*Date:* August 21, 2024  
*Refer To:* N3B-2024-0263

**Subject: Class 1 Permit Modification Request for Administrative Changes at Technical Area 54, Area G, Pad 9, of the Los Alamos National Laboratory Hazardous Waste Facility Permit, EPA ID No. NM0890010515**

**Class 1 Permit Modification Request  
for Administrative Changes at  
Technical Area 54, Area G, Pad 9, of  
the Los Alamos National Laboratory  
Hazardous Waste Facility Permit,  
EPA ID No. NM0890010515**

**Figure G.10-1: Technical Area G, Pad 9 Outdoor Container Storage/Treatment Unit Grid Sampling and Additional Sampling Locations**

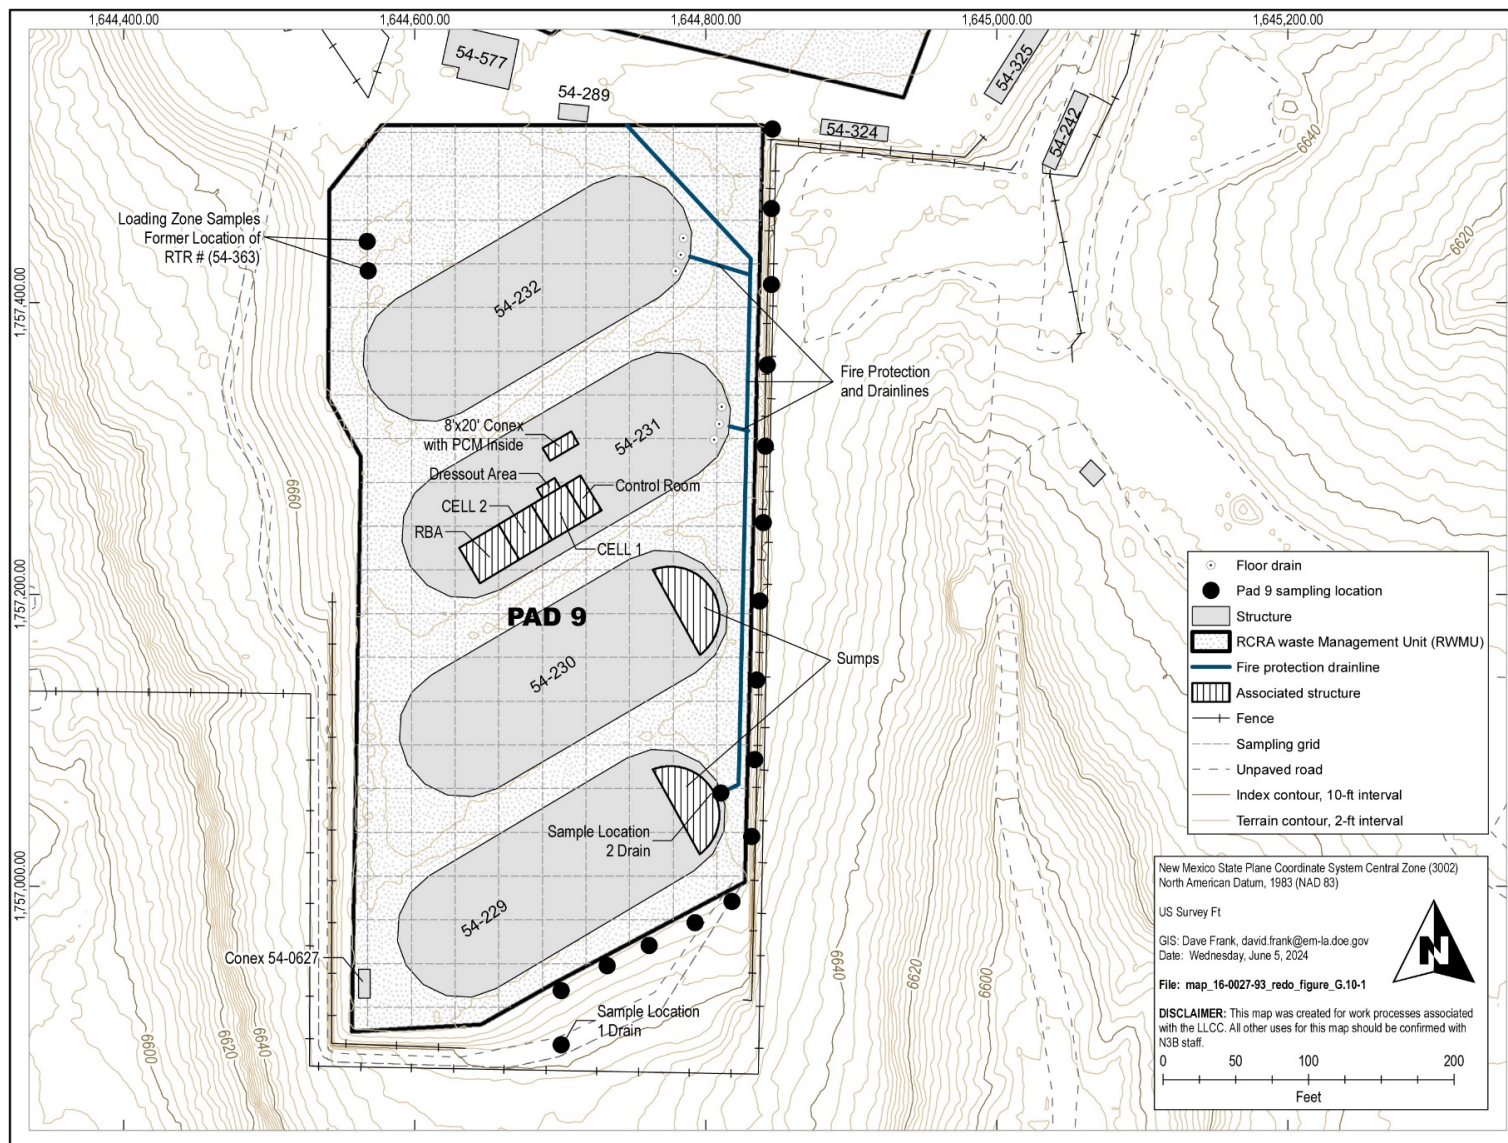
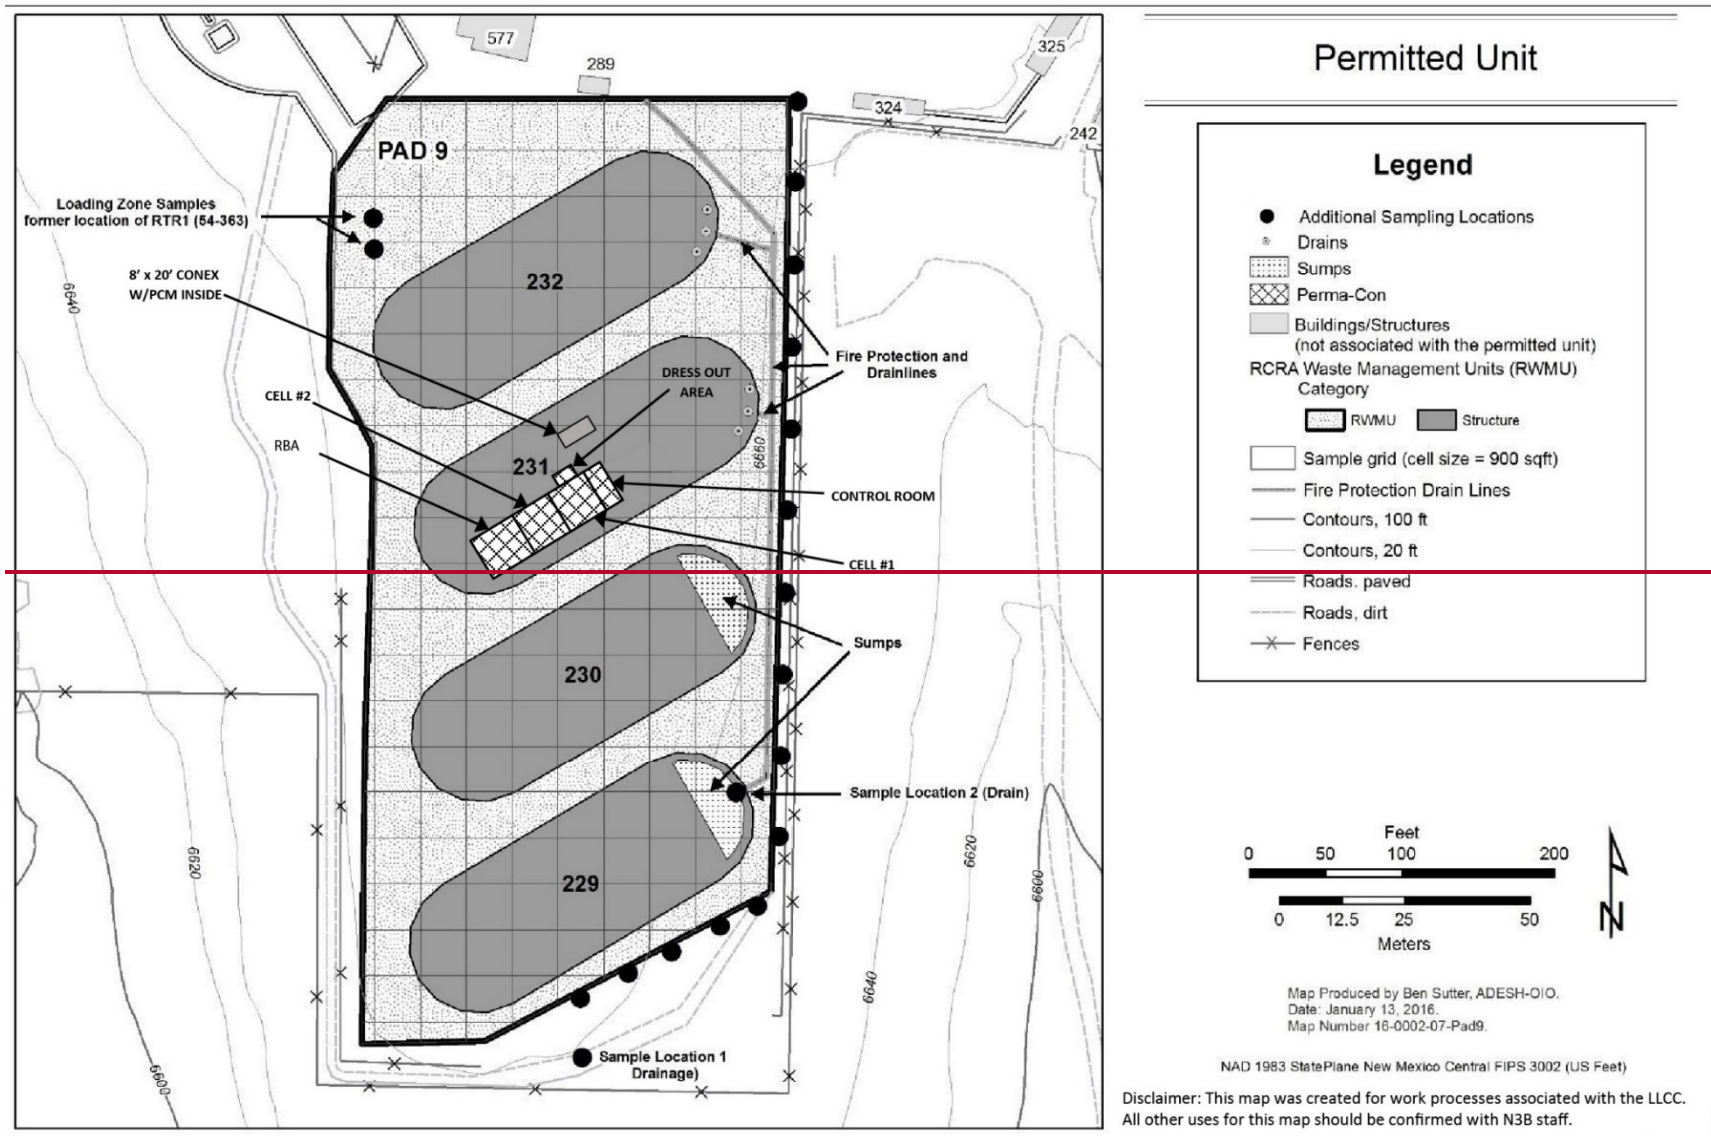
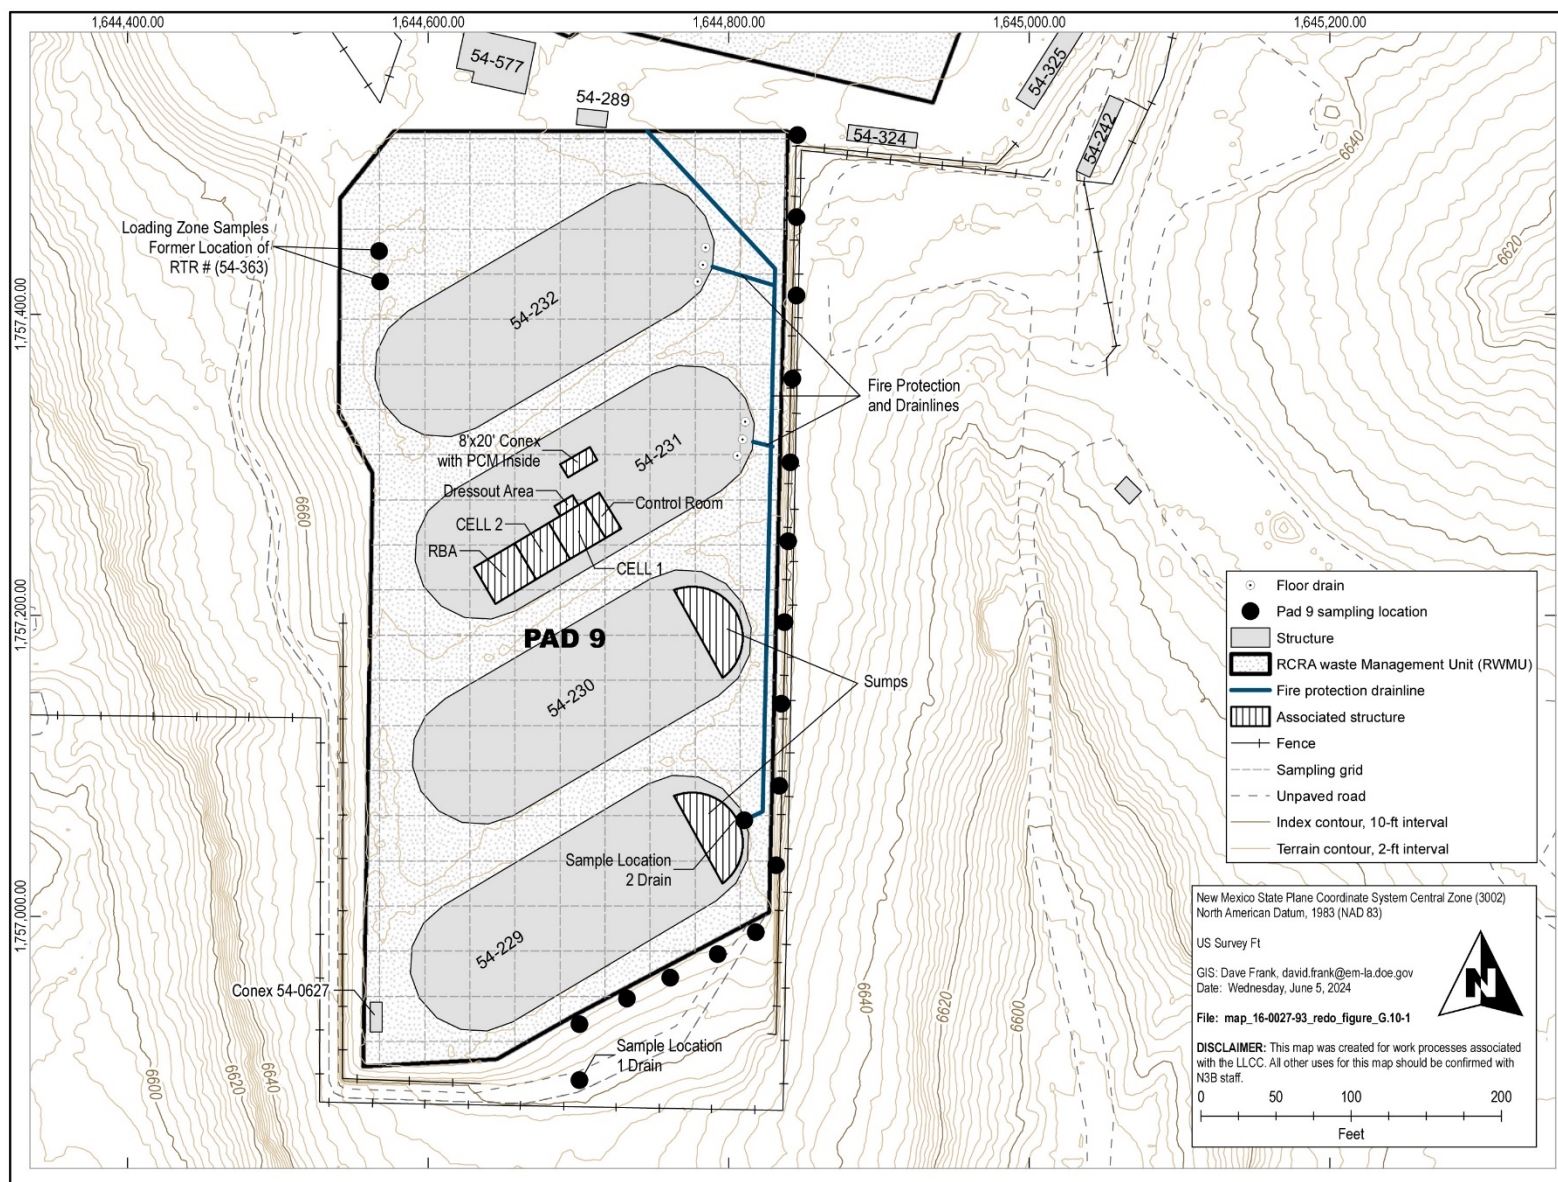
Changes described in this request do not substantially alter the permitted container storage requirements or facility. Changes include updated figures to show the location of the conex box, and minor revisions to text describing the new conex box.

The permitted unit is comprised of an asphalt pad which is located in the eastern end of Area G. It was constructed in 1993, consists of a four to six inch layer of asphalt over the underlying base course overlying fill (minimum six inches of tuff), and measures 570 feet long and 275 feet wide, or approximately 158,000 square feet. It is constructed with curbing on the west and east sides and is sloped from 1% to 1.5% to the east and south-east for drainage. Rainwater flow is directed across the pad by the eastward slope and through small PVC drains spaced at 55 foot intervals in the curbing along the east side of the pad. The slope below the curbing is protected with rock and concrete. Concrete curbing also extends along the west and partially the south sides of the pad and ends at a concrete and rock drainage structure. The remainder of the south side of the pad is uncurbed. Four domes ~~\_(Domes 229, 230, 231, 232)\_~~ and a conex box (54-0647) are situated on it (*see* Figure G.10-1).

**Figure 28: TA-54, Area G, Pad 9 Outdoor Container Storage/Treatment Unit (TWSP Domes 229, 230, 231, and 232)**

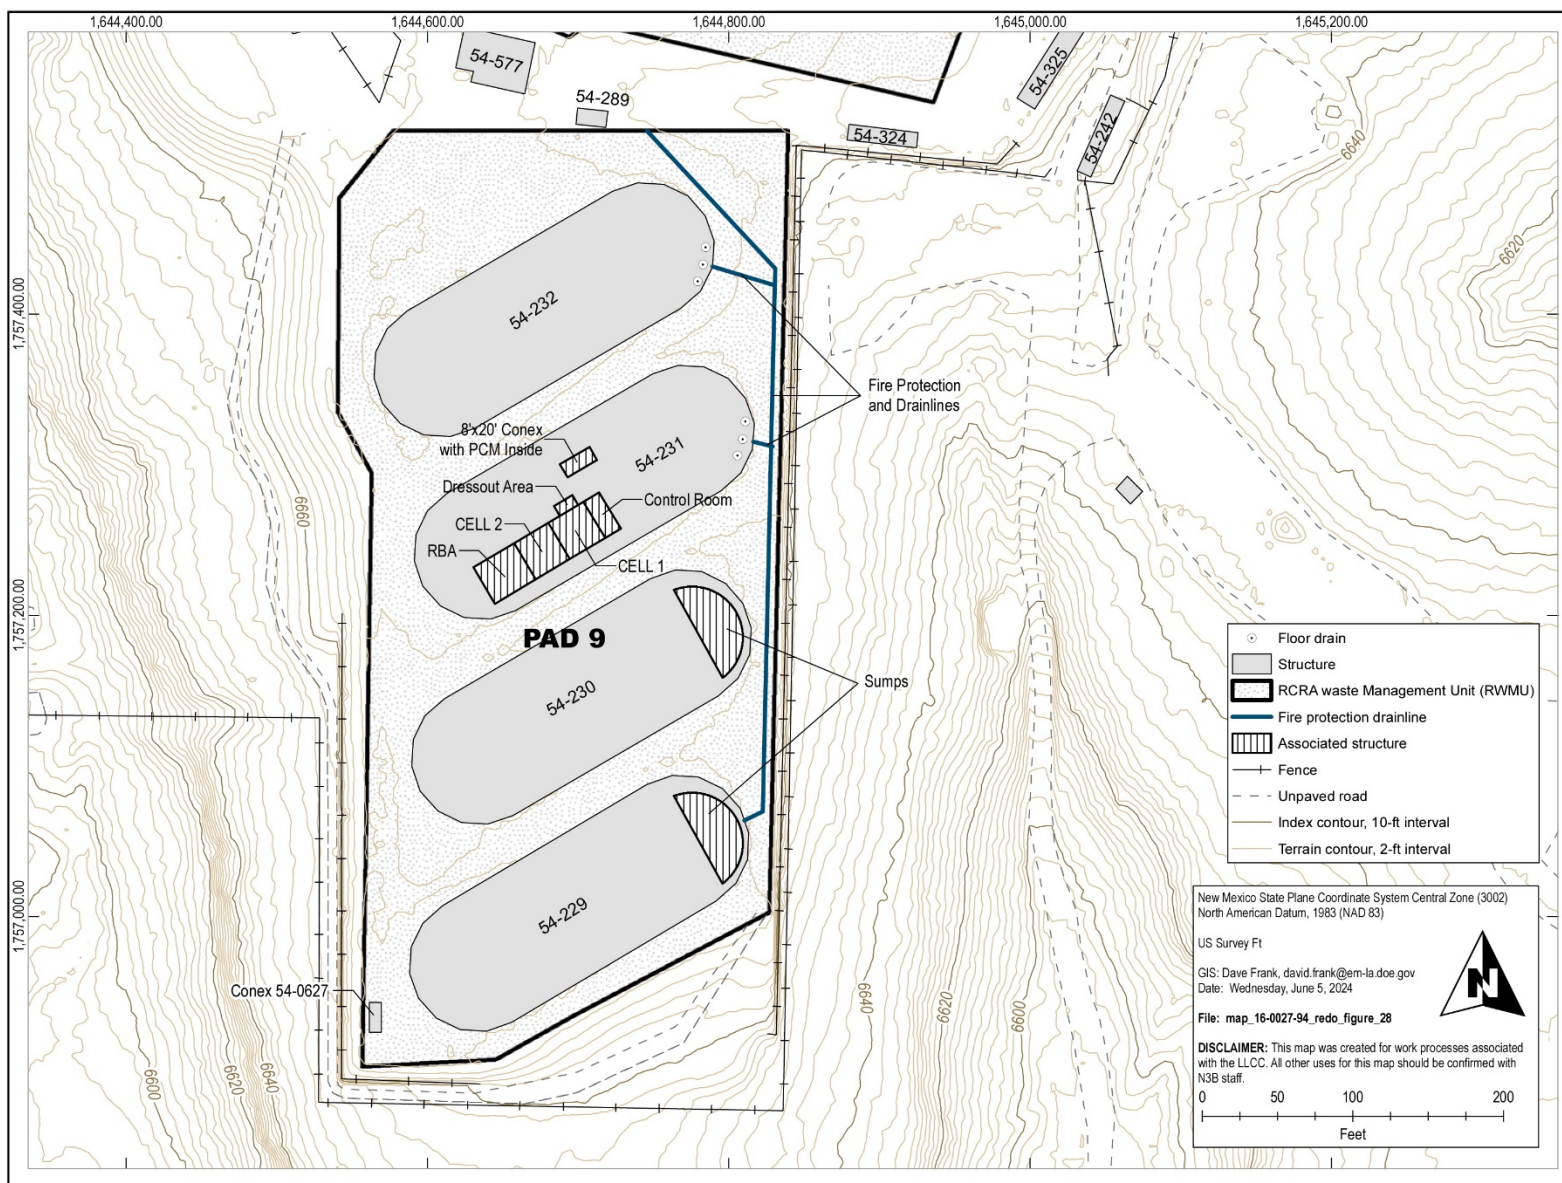
The 4 to 6 in thick asphalt pad is approximately 570 feet long and 275 feet wide (*see* Figure 28 in Attachment N (*Figures*)). Transuranic Waste Inspectable Storage Project (TWISP) domes 229, 230, 231, and 232 are located on Pad 9 at the east end of Area G. Each dome is approximately 246 ft long, ~~and 88 ft by 7 inches~~ 89 feet wide by 35 feet high, and consists of a rigid aluminum frame that supports a tensioned membrane. A series of aluminum I-beam trusses spanning the width of the structures comprise the dome framework. The membrane material is a polyester fabric coated with UV-stabilized plasticized PVC. The material is fungus-resistant and fire-retardant (*i.e.*, self-extinguishing). The membrane is integrally connected to the frame to provide a fully tensioned fit. Each dome is equipped with personnel doors and a roll-up door for vehicle access and is anchored to a concrete ring-wall with anchor bolts. Under Pad 9 is a fire water collection system that collects water from Domes 232 and 231 and transports it to a sump system in Dome ~~229~~ at the south end of Pad 9. The system is not intended for, nor was it designed to provide, secondary containment of liquid waste releases. It was designed to provide an augmented fire water collection capability to prevent fire water running off the pad if any fire suppression activities exceeded the capacity contained in the upstream domes. Domes 231 and 232 have three drain inlets apiece in the southeast portion of the domes. The drains in each dome are connected and drain to a collection pipe-line that runs down the east side of Pad 9. The line terminates in the collection sump in the east end of Dome 229. The floor of Dome 230 is designed for secondary containment of liquids. The asphalt pad floor is sloped (1%) towards a concrete sump at the east end of the dome. The asphalt floor and curbs in Dome 230 are lined with a double layer of 40 mil high-density polyethylene (HDPE), and the sump is lined with a single layer of 40 mil HDPE, creating an impervious layer to contain any liquids that might accumulate. The secondary containment capacity for Dome 230, which includes the sump and curbed area, is approximately 48,255 gallons which exceeds the amount necessary to hold 10% of the total storage capacity of the dome (330,000 gallons). The TWISP domes on Pad 9 are unheated; the storage of waste within the transportainer is for the purpose of temperature equilibration of the waste for characterization procedures (*i.e.*, real-time radiography and headspace gas sampling associated with the transuranic waste characterization program). Additionally, there is a conex box (54-0627) southwest of Dome 229 used for storage of radioactive calibration sources used for waste characterization activities. The conex box is approximately 20 feet long by 8 feet wide.
